PILATUS AIRCRAFT LTD. STANS, SWITZERLAND

PC-7 MKII

Service Bulletin No: 53-020 Ref No: 144

FUSELAGE - MAIN FRAMES REPLACE THE LEFT AND / OR RIGHT FRAME 11 FITTINGS

Removal / Installation of the Elevator-Rear Control-Rod Figure 1

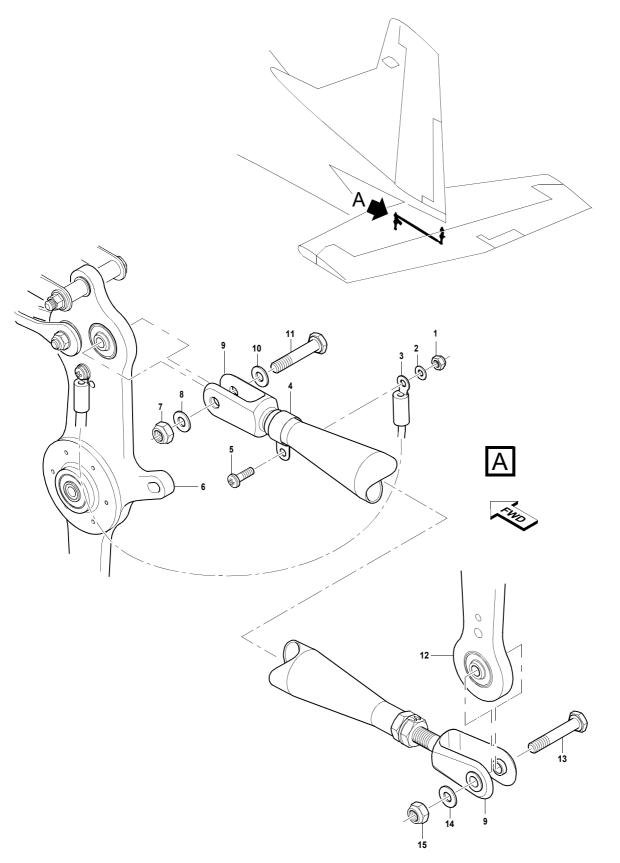
- (3) For better access, you can remove the elevator rear control-rod as follows (Ref. Fig. 1):
 - (a) Remove the nut (1), the washer (2), the bonding strap (3) and the screw (5). Discard the nut (1).

- (5) If necessary, install the elevator rear control-rod as follows (Ref. Fig. 1):
 - (a) Put the elevator rear control-rod (9) in position between the lever assemblies (6) and (12).

- (b) Apply a layer of corrosion preventative (Material No. P04-039) to the shaft of the bolts (11) and (13).
 - (c) Install the bolt (13), the washer (14) and the new nut (15) (P/N 938.07.68.305).

- (d) Install the bolt (11), the washers (10) and (8) and the new nut (7) (P/N 938.07.68.305).
 - (e) Put the screw (5) through the loop clamp (4).
 - (f) Put the bonding strap (3) and the washer (2) on the screw (5). Install the new nut (1) (P/N 938.07.68.303).

Frame 11 Fittings - Removal / Installation Figure 2

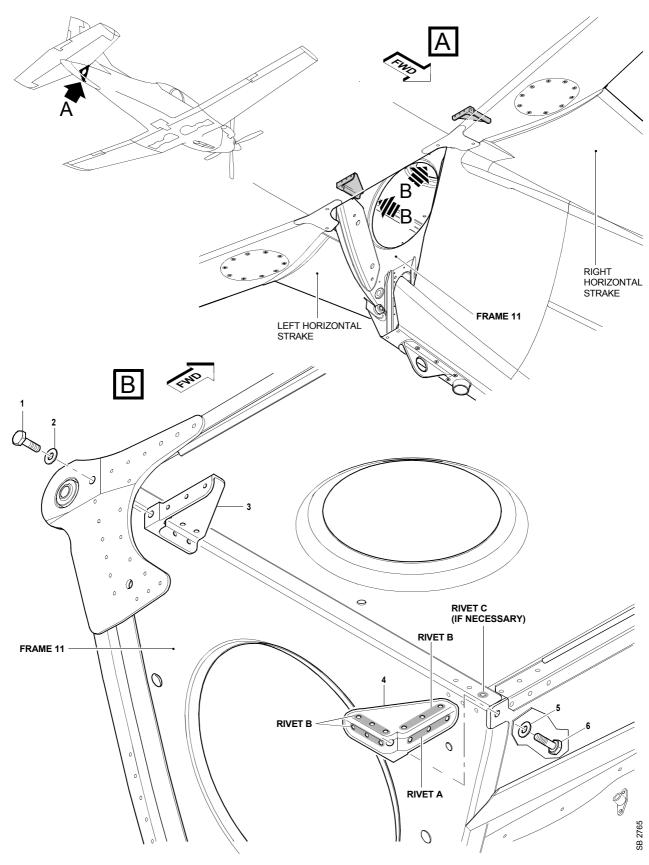
A mandatory crack inspection of the left and right FR11 fittings (known hereafter as "fittings"), P/N 112.35.07.489 and P/N 112.35.07.490, made from AA2024-T351 could require a replacement of the left and / or right FR11 fittings.

The cause of the cracks is stress corrosion.

Replace the fittings with new items made from material with an increased resistance to stress corrosion cracking.

- Clean the surface areas with absorbent paper (Material No. P02-031) made moist with solvent (Material No. P01-010).
- (c) Use the correct size diameter drill and remove the twelve rivets that attach the fitting (4) to aircraft structure. Remove the rivets in this order:

- (g) Put the new fitting (4) (Pos. No. 1) in position and hold with the new bolt (6) (Pos. No. 3) and the new washer (5) (Pos. No. 4).
- (h) Make sure the new fitting (4) (Pos. No. 1) is a good fit in the aircraft structure.

- (i) Use clamps (or equivalent) to hold the new fitting (4) (Pos. No. 1) to the fuselage structure.
- (j) Drill 3,3 mm (0.13 in.) holes in the new fitting (4) (Pos. No. 1) for the rivets A. Do this through the holes in the side panel skin.

- (k) Use a center punch and make marks in the new fitting (4) (Pos. No. 1) to show the center for the rivets B.
- (I) Remove the new bolt (6) (Pos. No. 3) and the new washer (5) (Pos. No. 4).
- (m) Remove the clamps (or equivalent).
- (n) Remove the new fitting (4) (Pos. No. 1).
- (o) Use a pillar drill (or equivalent) and a 4,1 mm (0.16 in.) drill to drill the holes in the new fitting (4) (Pos. No. 1) for the rivets B.

- Install the rivets (Ref. SRM 51-40-00). Install the rivets in this order:
 - <u>a</u> Install the rivets that attach the new fitting (4) (Pos. No. 1) to FR11.
 - <u>b</u> Install the rivets that attach the new fitting (4) (Pos. No. 1) to the side panel.
 - <u>c</u> Install the rivets that attach the new fitting (4) (Pos. No. 1) to the top panel.

NOTE: A Cherrymax rivet (CR3223AD5 - length are to be determined during installation) can be used for the most outboard rivet that attaches the new fitting (4) (Pos. No. 1) to the top panel, on the side of FR11 (Ref. Fig. 2).
